SUMMARY OF CONCERNS IN RELATION TO THE PROPOSED NORTHCONNEX TUNNEL

This is an objection to many aspects of the proposed NorthConnex tunnel.

SECTION A: THE CONNECTIVITY OF NORTHCONNEX SOUTHERN VENTILATION FACILITY AT THE SOUTHERN INTERCHANGE, THE SOUTHBOUND TUNNEL IN PARTICULAR

Figure 5-17 Motorway operations complex

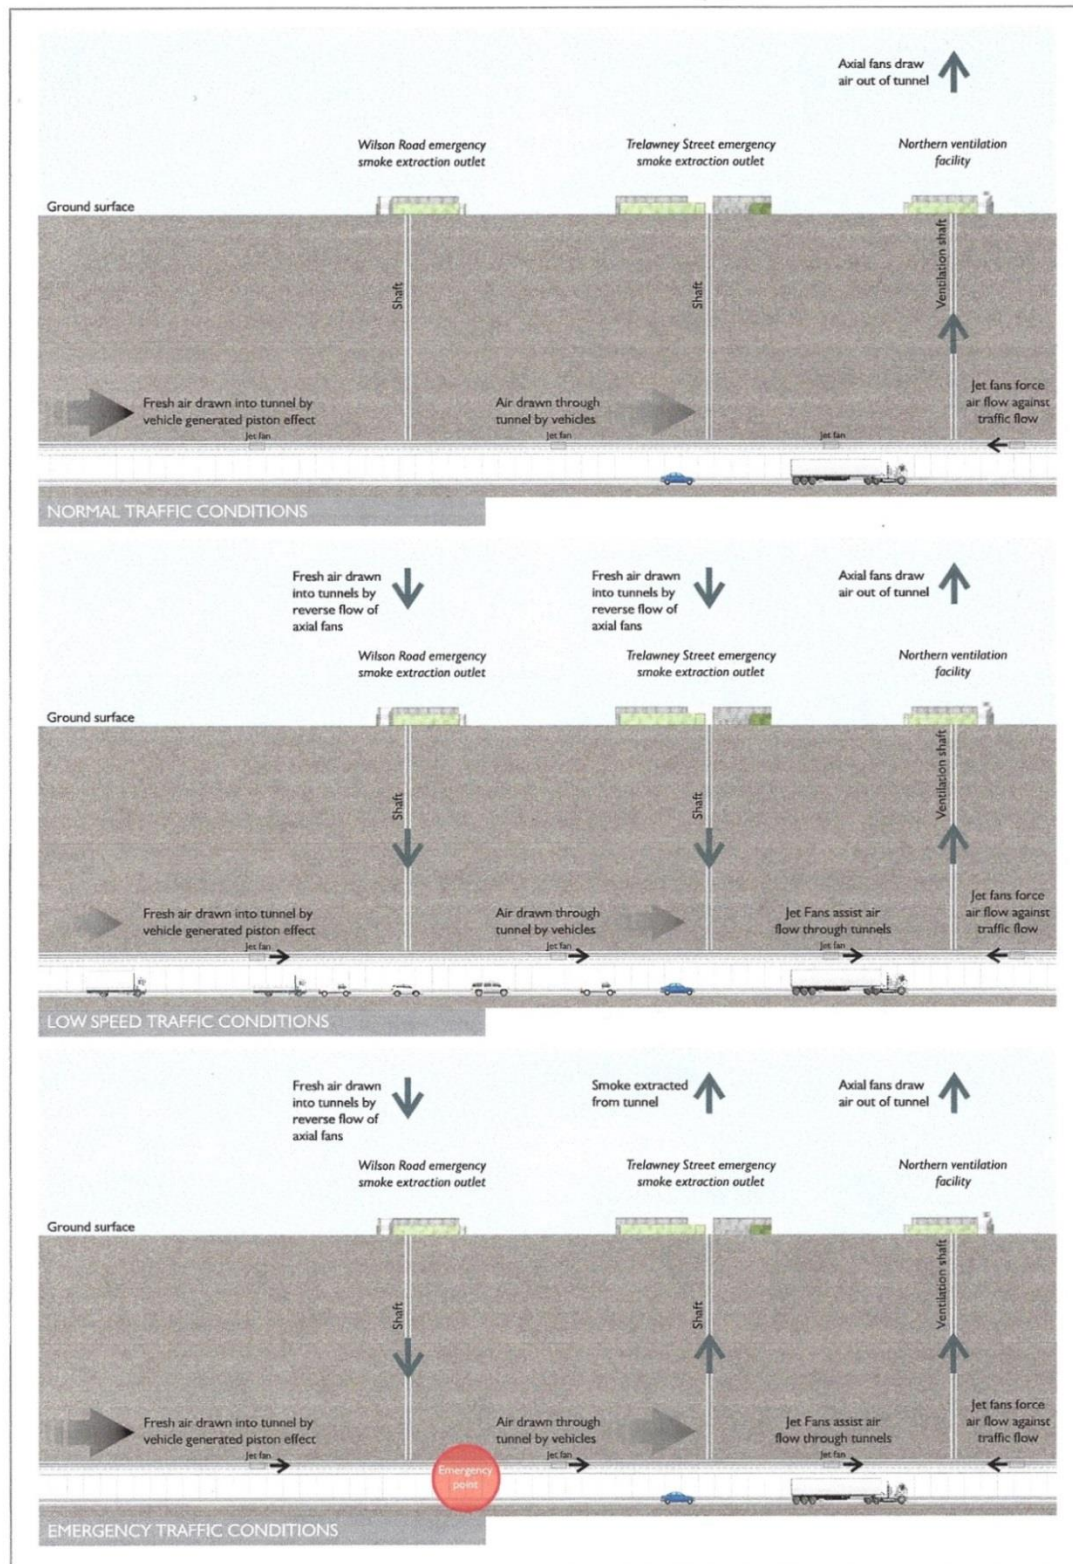
EIS Page 111, *Figure 5-17 Motorway operations complex*

Page 8 below there is no indication of how the ventilation facility will be connected to either the northbound or southbound tunnel, nor is there any indication of how the southbound exit portal onto Pennant Hills Road or the south-west exit portal onto the M2 will be connected.

In each of the above figures for Wilson Road, Trelawney Street, and Northern Ventilation facility, the shafts, emergency smoke extraction buildings, and ventilation facility make a substantial footprint in the construction area; however for the Southern Interchange the ventilation facility is an insignificant part of the construction area. How can this be? The difference in scale does not explain the difference.

We also find it disturbing that in each of the above figures for Wilson Road, Trelawney Street, and Northern Ventilation facility the headings are for “*tunnel support facility operational layout*” and “*ventilation facility operational layout*” but for the Southern Interchange the description is for “*Motorway operations complex*” with no mention of the ventilation facility or the tunnels.

- Diagrams need to be provided showing the inter-relation between the shaft, the ventilation outlet and the motorway operations centre with a clear description of what is to be constructed and how it will operate.
- The community needs irrefutable evidence that the polluted air from the southbound tunnel exit portals will not be allowed to flow like an invisible sewer through West Pennant Hills, North Rocks, Carlingford and Beecroft.

Figure 5-38 Indicative southern interchange construction compound

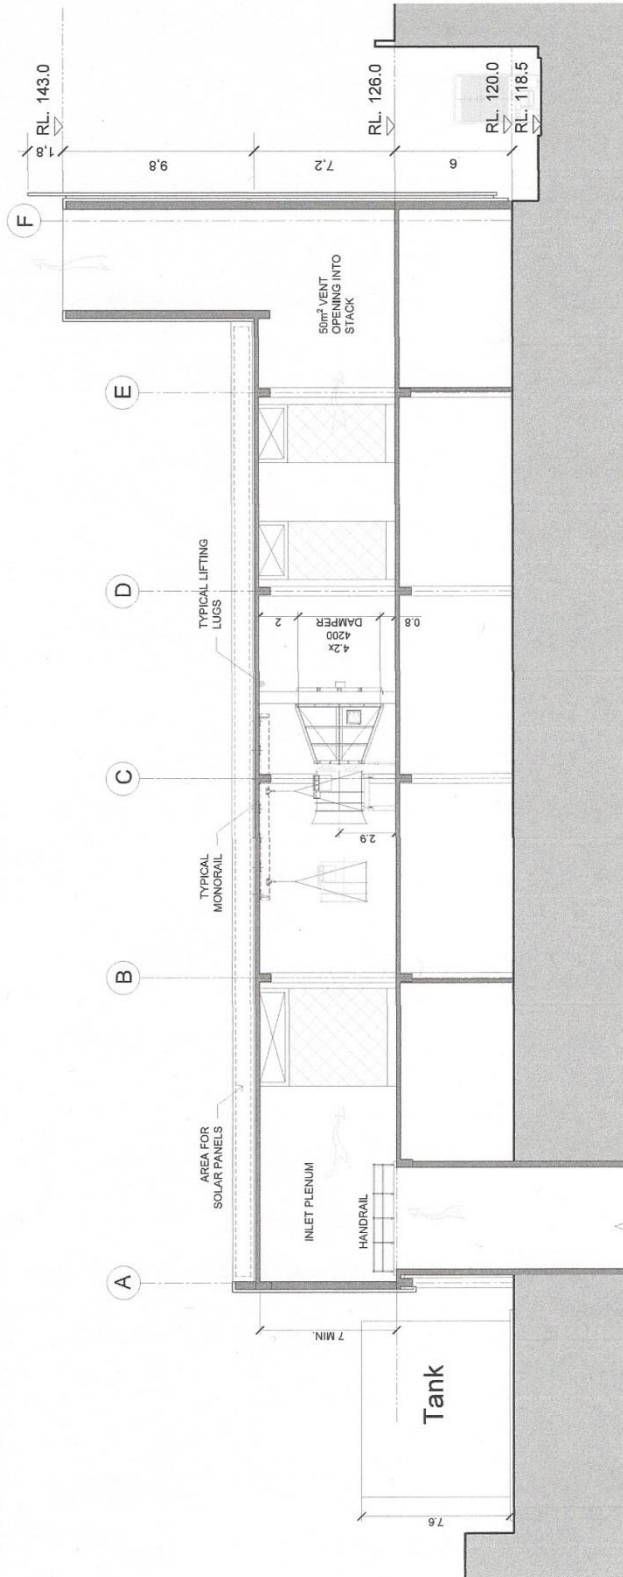
3. EIS Page 189 *Figure 5-38 Indicative southern interchange construction compound* *Page 9 below*

It is ominous that the southern ventilation facility and shaft are completely absent from Figure 5-38.

MOTORWAY OPERATIONS COMPLEX - SOUTHERN VENTILATION FACILITY - SECTIONS
M1-M2-5000-DR-JD-0525

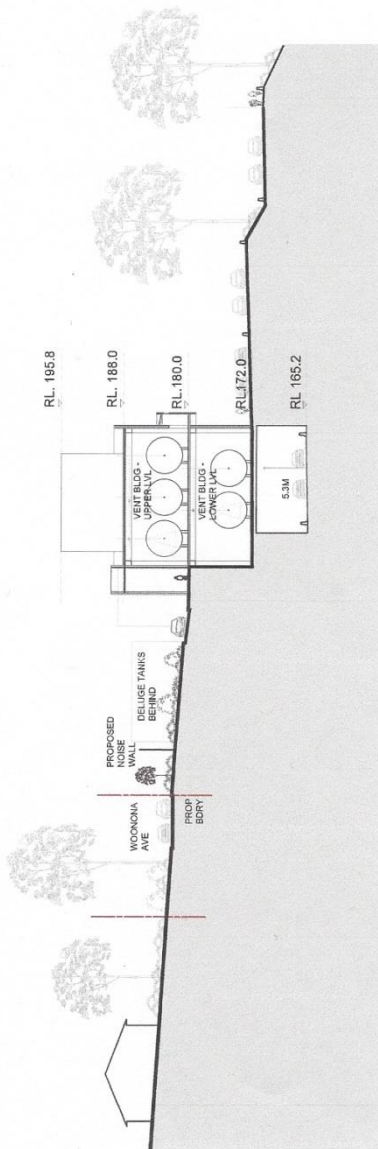
5. *EIS Volume 4, Technical working papers - Urban Design, 6.0 Operational Ancillary Facilities*
EIS Page 99 there is the diagram "Motorway Operations Complex – Southern Ventilation Facility – sections. *Page 10 below* The diagram has the cryptic label "Connection to tunnel TBC". What does TBC stand for? To be considered? Why is tunnel singular? Which tunnel is the diagram referring to northbound or southbound? There is no diagram showing any connection from the Southern Interchange ventilation facility to either the northbound or the southbound tunnel in any way AND YET
